NO	QUESTION	ANSWER
1	<p>The gross* area of the LGS building in the current situation is 6,400 m² (including the ground floor, the 1st floor and the basement, but excluding the existing navigation tower).</p> <p>In the Competition Programme, the total floor area of the competition object (without tower floors) is planned to be ~2,100 m².</p> <p>The question is whether this area (2,100 m²):</p> <p>a) is to be summed up with the existing area of 6,400 + 2,100 = 8,500 m²;</p> <p>b) is included in the existing area of 6,400 m².</p> <p>In variant (a), we would like to see the functions of the existing building (legend of spaces), if they remain unchanged and the new required spaces (programme) are located in the extension to the building?</p> <p>In variant (b), we would like to find out what functions need to be retained beyond the "programme".</p> <p>6,400-2,100 = 4,300 m²?</p>	<p>The LGS Competition Programme lists the additional spaces to be designed for the existing administrative building, i.e. their area is to be summed up with the area of the existing spaces.</p> <p>As regards the legend of the premises, the additional spaces are added to the existing administrative spaces.</p>

D

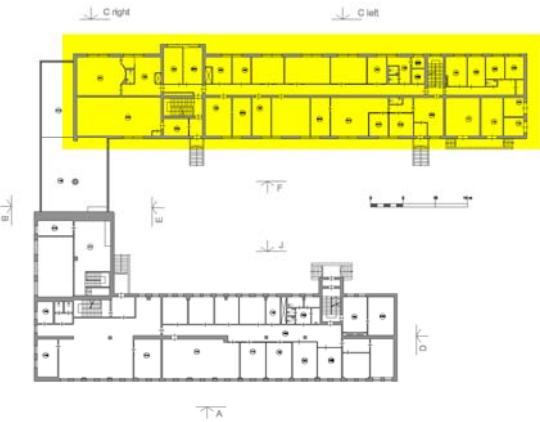
2	<p>Is it possible to demolish the part of the LGS building (located closer to the runway) (see marked yellow)?</p> 	<p>No, it is not intended to demolish it.</p>
3	<p>Should the existing navigation tower and its operation be maintained until the construction of the new navigation tower?</p>	<p>Yes, the operation of the existing traffic control tower must be maintained.</p>
4	<p>Should the existing LGS building form a single building together with the new navigation tower and other functions included in the Competition Programme or can the tower together with the spaces located on the lower floors be an independent structure?</p>	<p>The architectural and functional solution of the administrative building and the ATC tower must ensure comfortable daily operation and use of the spaces; their design is free expression of Participants' creativity.</p>
5	<p>The German DFS Guidelines specify 4 best possible locations for a navigational tower, two of which (3a and 3b) are shown. Is it possible to find out which are the other two?</p>	<p>The other two potential locations of the ATC tower specified in the DFS Guidelines are not related to the location of the particular Competition Object, therefore this information is not included in the Competition documents.</p>
